UNITED STATES  
DEPARTMENT OF THE INTERIOR  
BUREAU OF LAND MANAGEMENT

FORM APPROVED  
OMB NO. 1004-0137  
Expires: January 31, 2018**SUNDRY NOTICES AND REPORTS ON WELLS**  
*Do not use this form for proposals to drill or to re-enter an abandoned well. Use form 3160-3 (APD) for such proposals.*5. Lease Serial No.  
NMNM56749

8. Well Name and No.  
TEXACO FEDERAL 029. API Well No.  
30-025-30943-00-S210. Field and Pool or Exploratory Area  
SWD11. County or Parish, State  
LEA COUNTY, NM**SUBMIT IN TRIPLICATE - Other instructions on page 2**

**Permanent Abandonment of Federal Wells  
Conditions of Approval (LPC Habitat)**

Texaco Fed 2 SWD  
1980' FNL, 2310' FEL  
G-14-195-33c  
Lco, NM

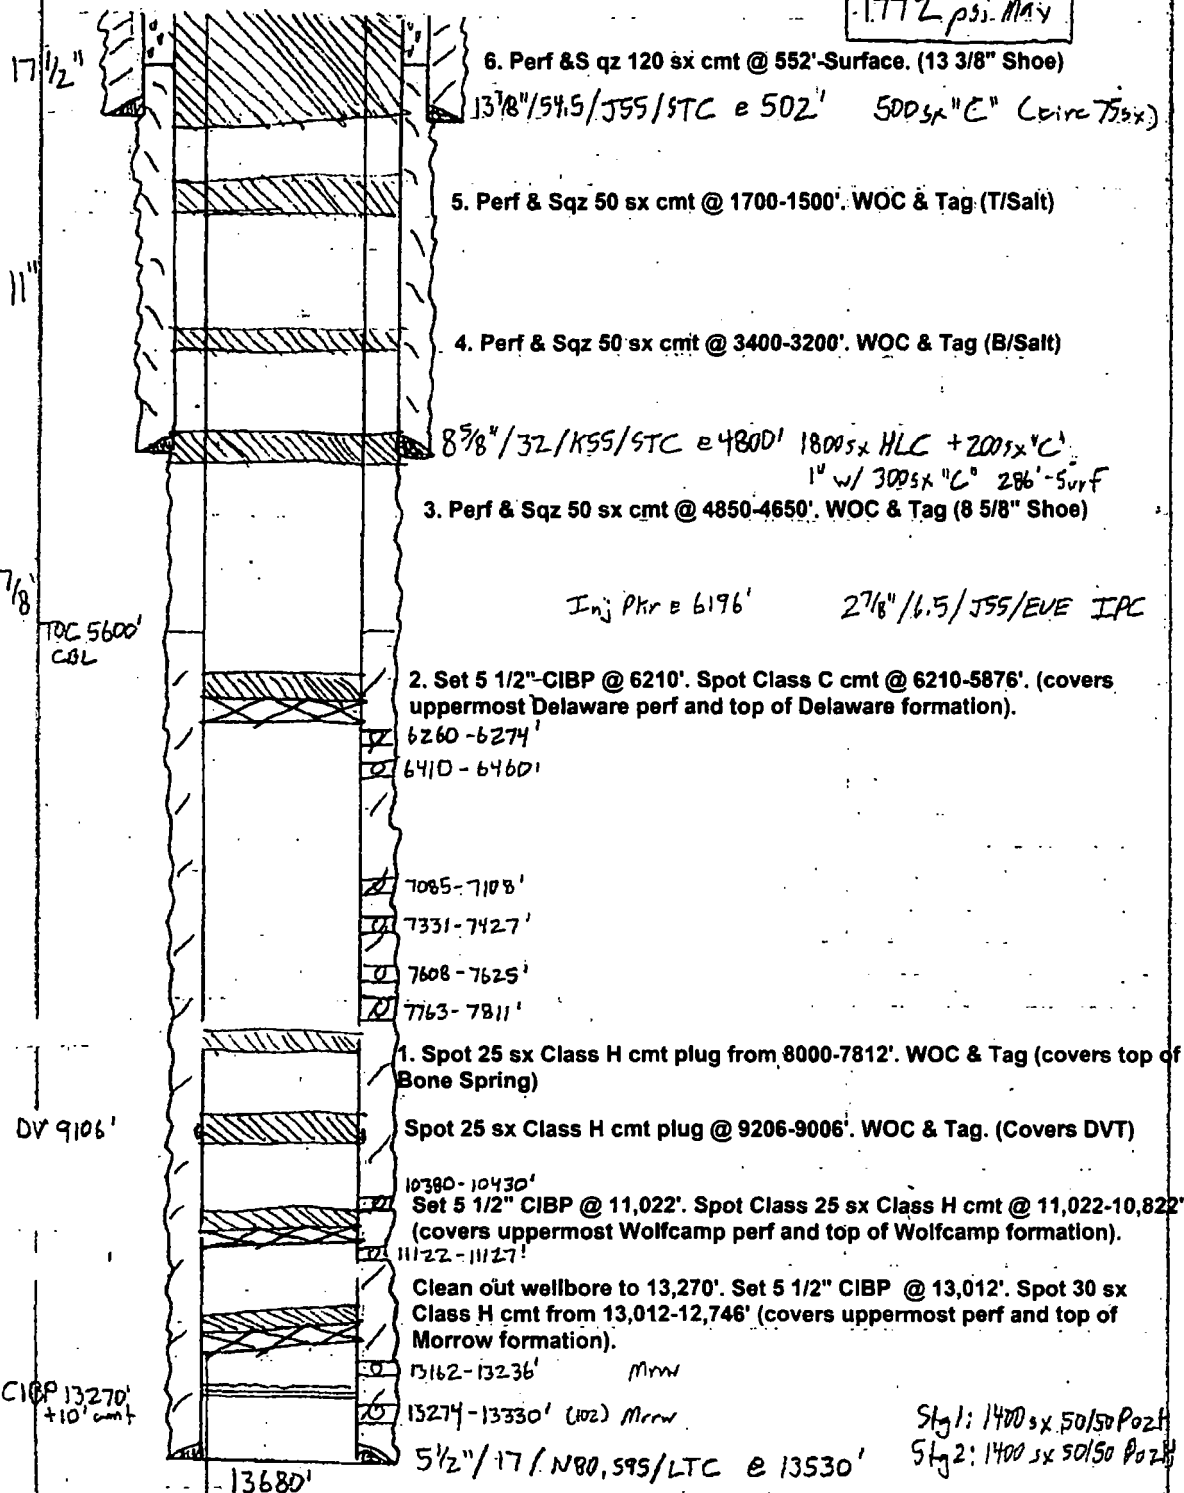
SEE ATTACHED FOR  
CONDITIONS OF APPROVAL*Below ground level dry hole marker required*

\*\* BLM REVISED \*\* BLM REVISED \*\* BLM REVISED \*\* BLM REVISED \*\* BLM REVISED \*\* ONLY

4. Perf & Sqz 50 sx cmt @ 3400-3200'. WOC & Tag (B/Salt)
5. Perf & Sqz 50 sx cmt @ 1700-1500'. WOC & Tag (T/Salt)
6. Perf & S qz 120 sx cmt @ 552'-Surface. (13 3/8" Shoe)
7. Cut off well head, verify cmt to surface, weld on Below Ground Dry Hole Marker.
